#### **PROPOSAL OUTLINE**

- 1. CONDITION OF APPROVAL D: PERIMETER FENCING
- 2. CONDITION OF APPROVAL E: VIEW SHED
- 3. ROOF CANOPY MATERIAL
- 4. SOUTH VERTICAL TOWER MASSING
- 5. LEVEL 2 GLAZING / BALCONIES
- 6. SMOKE EXHAUST LOUVERS
- 7. LIGHT RAIL POLE PLACEMENT

CONDITION OF APPROVAL D - FENCING PROPOSED FENCING

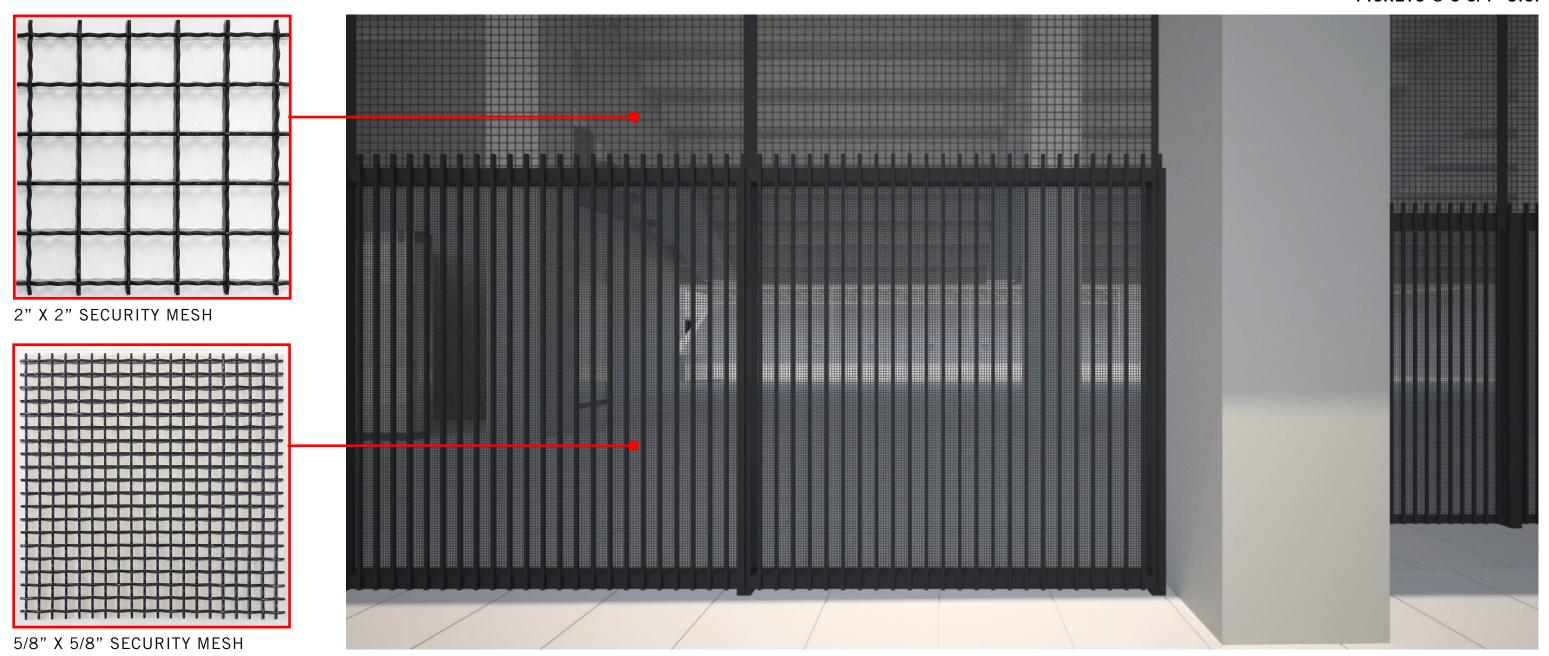
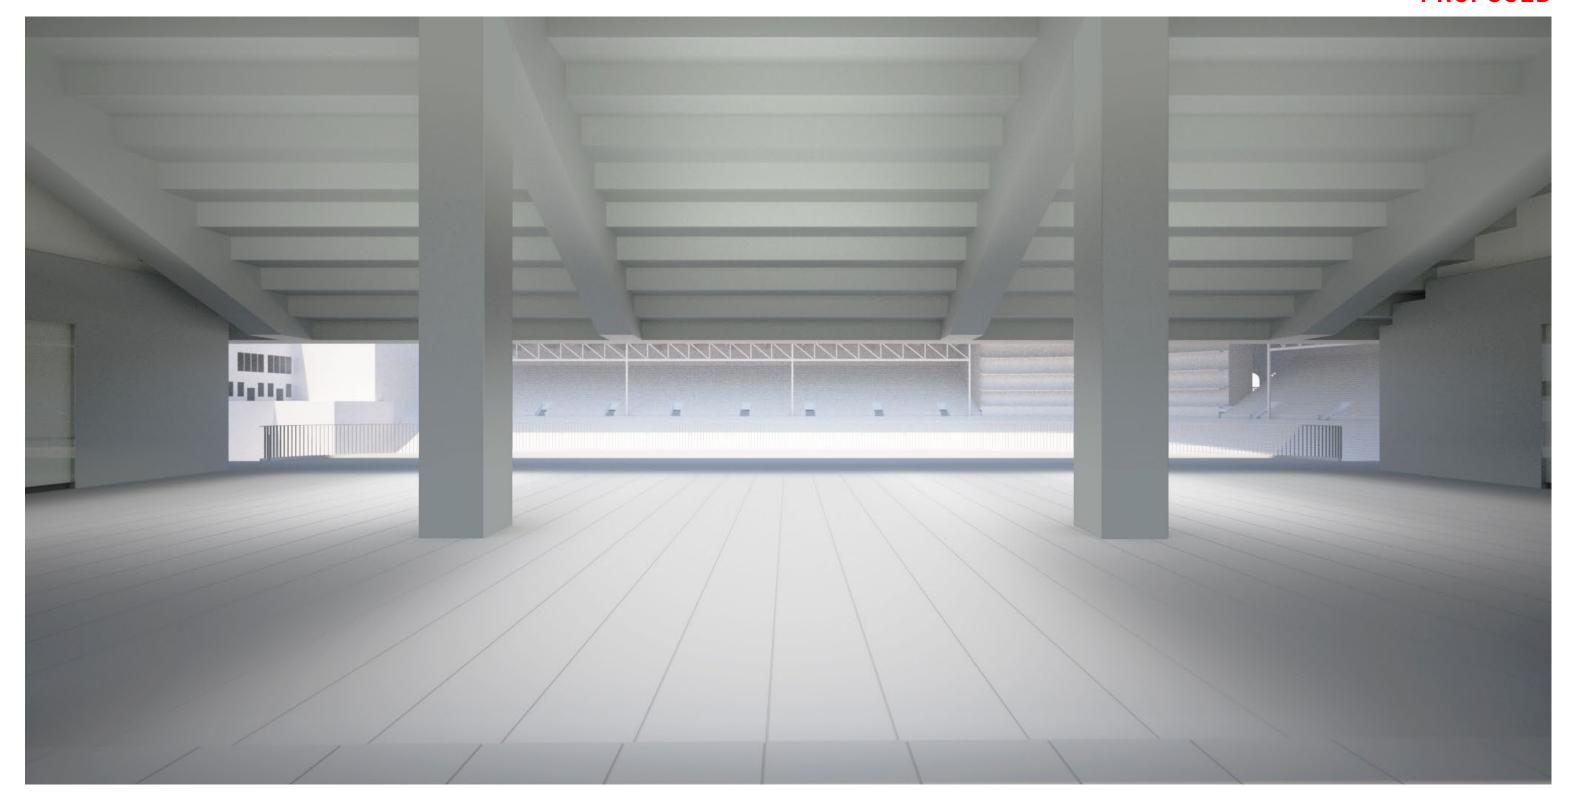
2" X 2" SECURITY MESH ABOVE 1" X 1" SECURITY MESH BELOW PICKETS @ 7 3/4" O.C.

#### REVISED LOWER SECURITY MESH TO ADDRESS SECURITY CONCERNS

## PROPOSAL ITEM 2. APPROVED STADIUM VIEW SHED

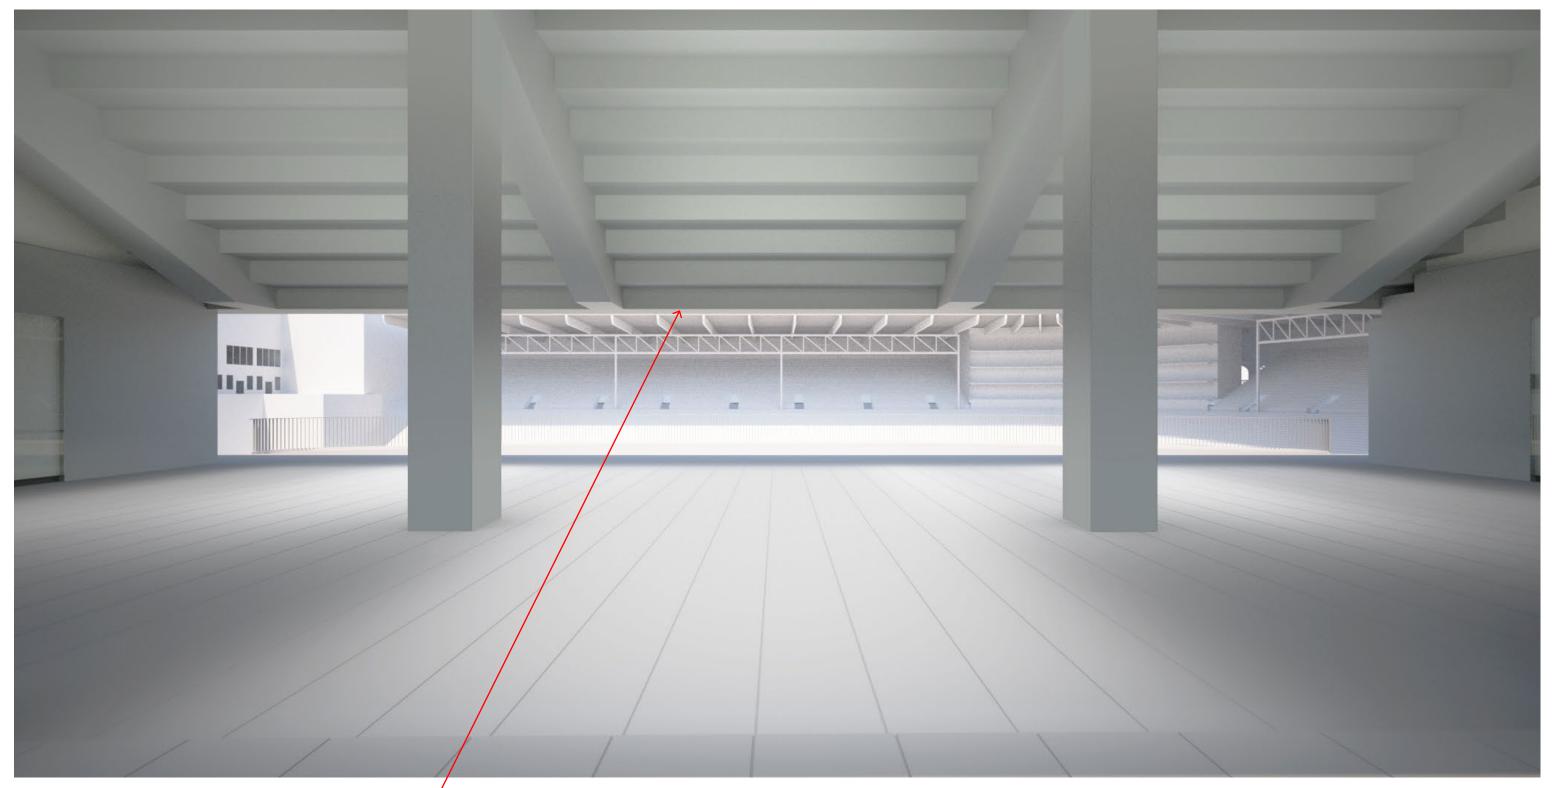
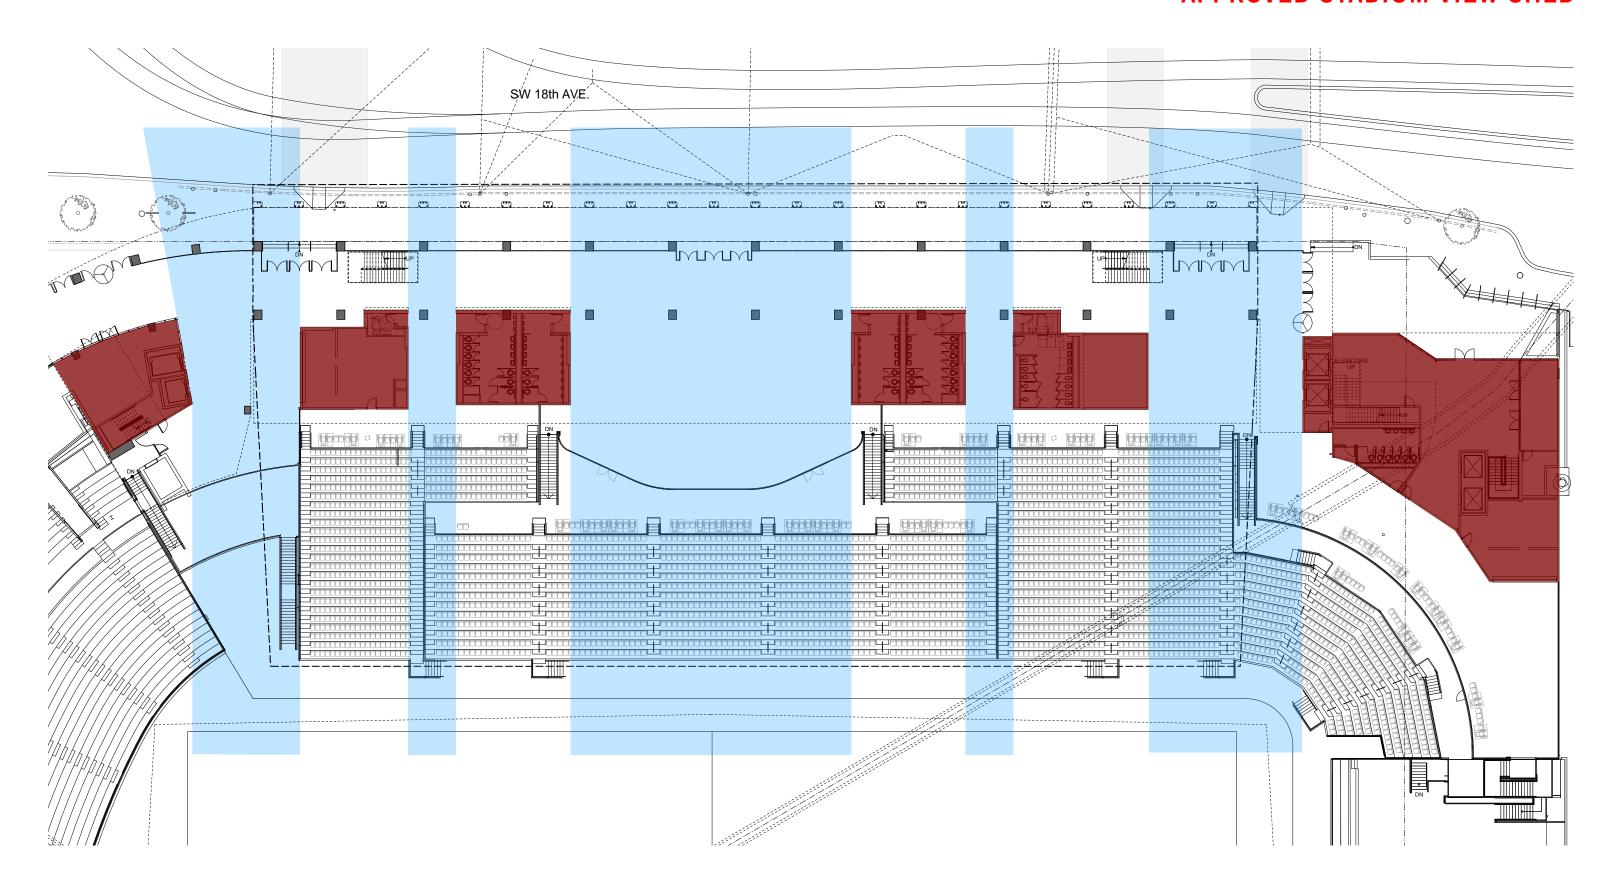
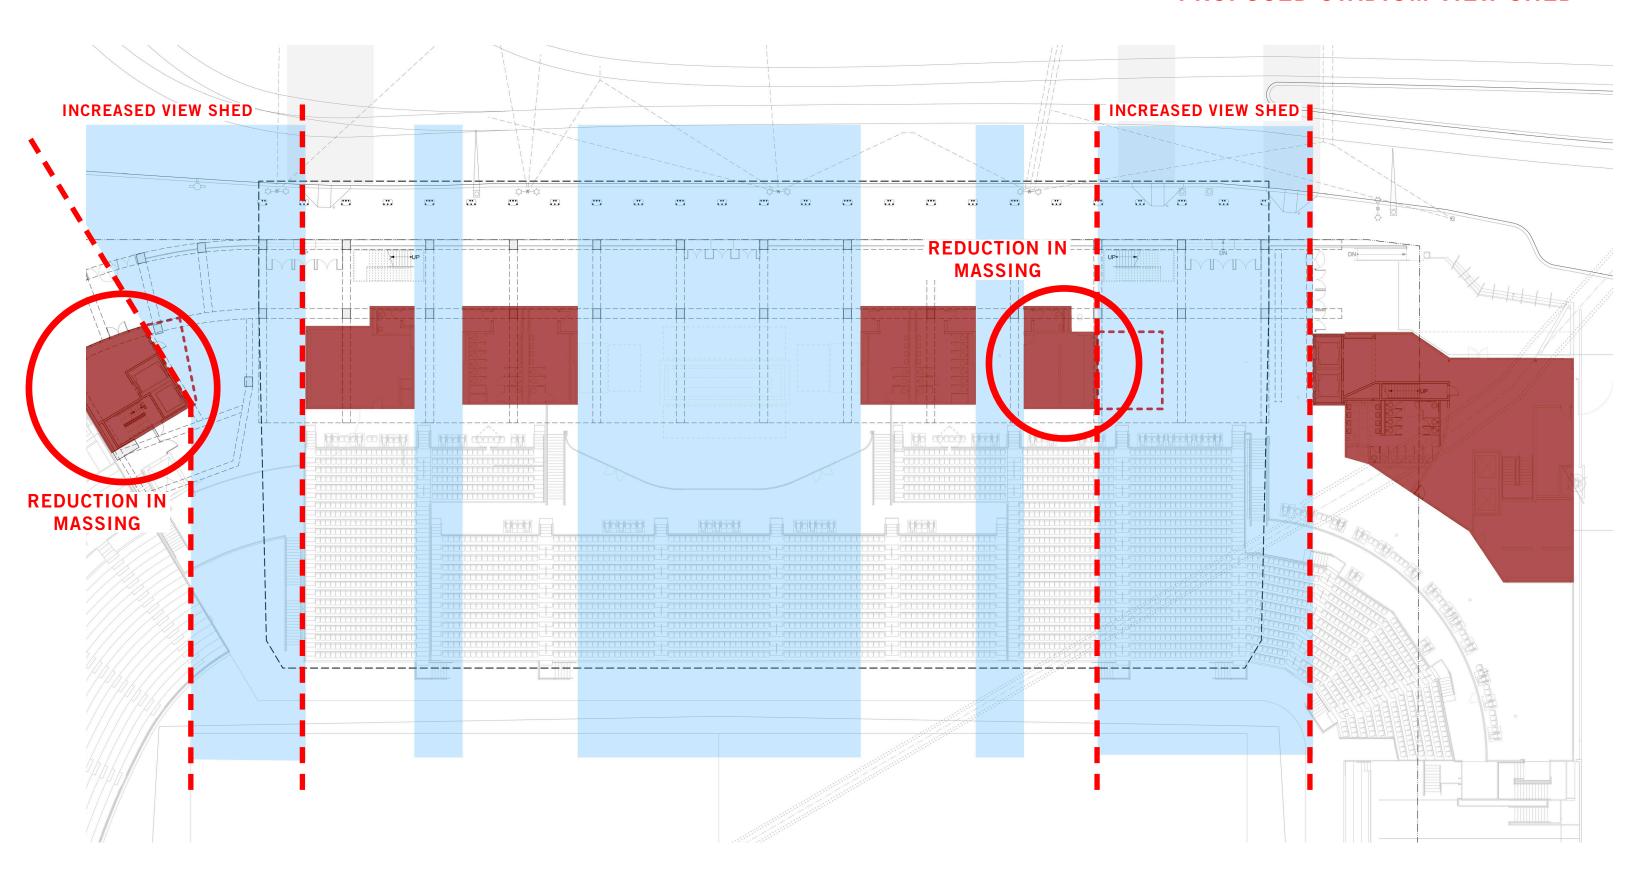
REMOVAL OF 160 SEATS-PROVIDES VIEW OF EXISTING ROOF RAFTERS

CENTRAL VIEW SHED INTO STADIUM PER DESIGN REVIEW CONDITIONAL APPROVAL

## PROPOSAL ITEM 3. PROPOSED ROOF CANOPY MATERIAL

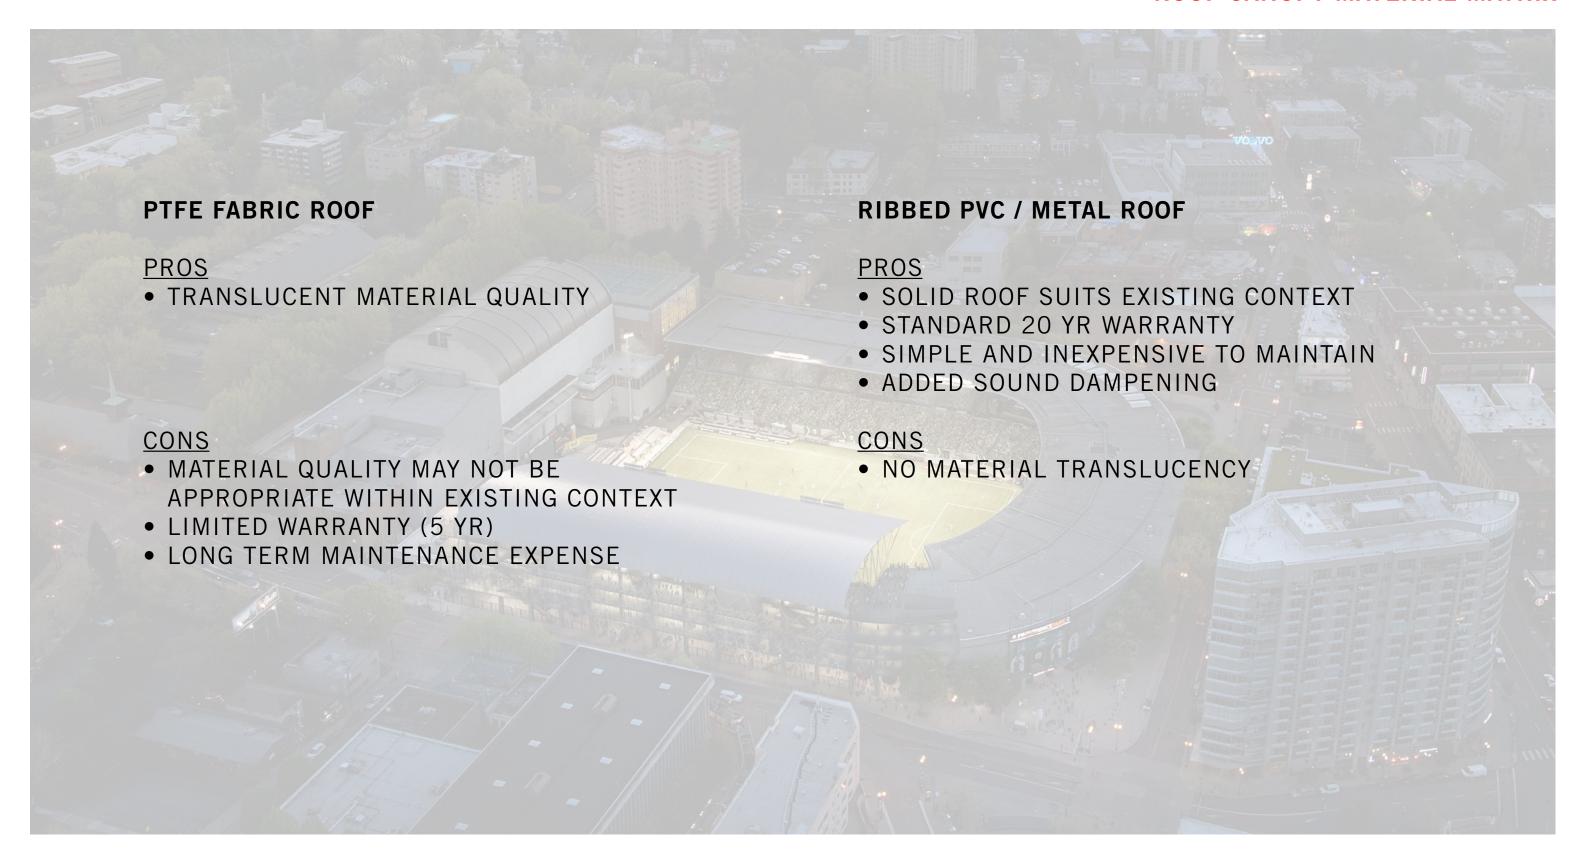
FABRIC ROOF CANOPY PRESENTED AT DESIGN REVIEW
PTFE ROOF CANOPY MATERIAL

REVISED ROOF CANOPY MATERIAL SOLID ROOF CANOPY

## PROPOSAL ITEM 4. SOUTH CORE MASSING

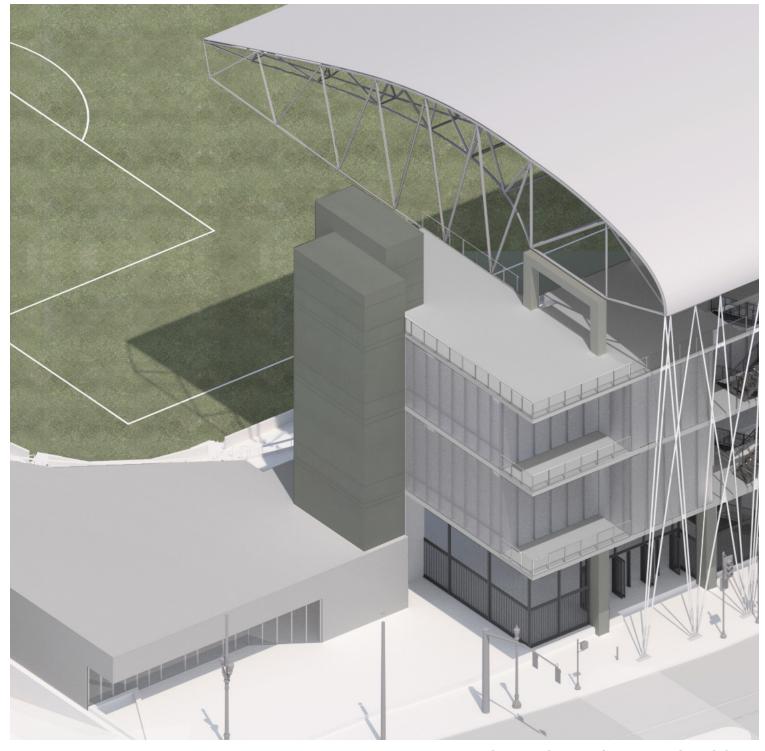
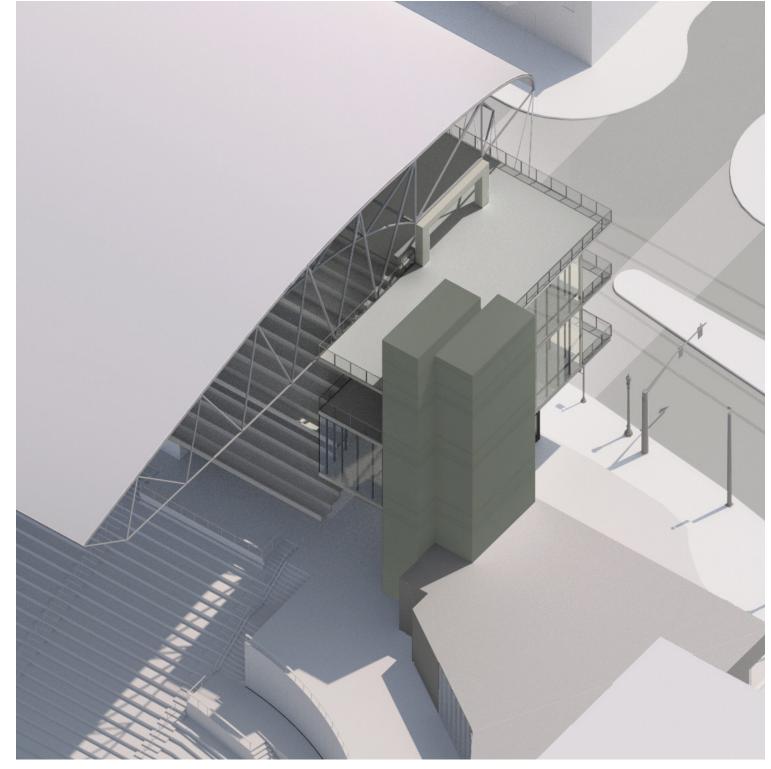
APPROVED STAIR/ELEVATOR CORE

PROPOSED STAIR/ELEVATOR CORE
